Access Compliance Report

Public Rights-of-Way (Curb Ramps)

Intersection ID: 15049	Main Street: DILWORTH_RD_WEST	Cross Street: MAGNOLIA_AV	Location: SW
ADA ID: 9A3F18BE577D	Ramp Type: Directional1	Initial Pass/Fail: Fail	Overall Compliance: No
Severity Score: 10			
Codes/Mitigation Info/Possible Solution		Field Measurements/Component Compliance

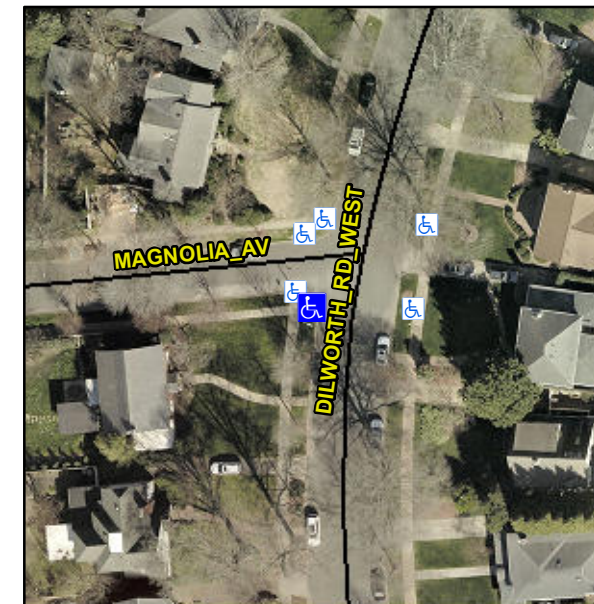
R304.5.1, R304.5.3

Remove & Replace Entire Ramp.
